Subject ▶ Change on balance plate and related parts

For Models ▶ 4304,4305 (Jig Saws)

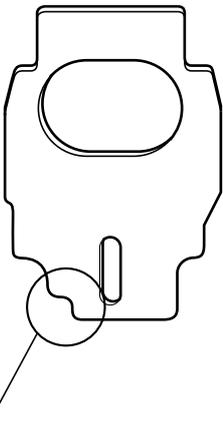
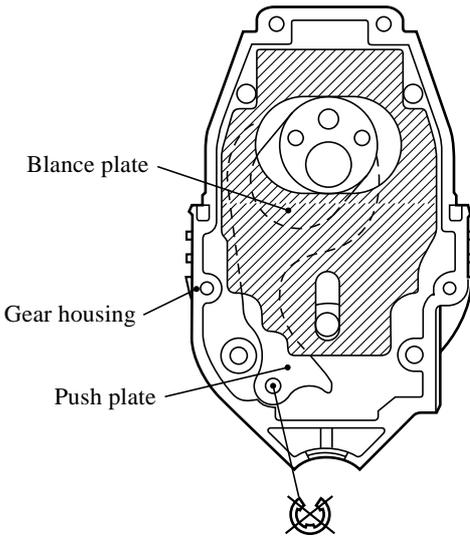
Description ▶ As described below, three parts have been changed to reduce vibration

▶ Current	▶ New	
Balance Plate		 <p>Please make sure the shape of bottom left side corner is the same as shown above.</p>	 <p>Stop Ring E-4 has to be taken out when you change to new balance plate.</p>
Slider		No change in shape but manufacturing process

Item No.	Current part	Q'ty	I/C	New part	Q'ty	Note
25	Balance Plate 344133-4	2	Yes	Balance Plate 344330-2	2	
42	Stop Ring E-4 961011-9	1				
19	Slider 313069-8	1	<=	Slider 310028-3	1
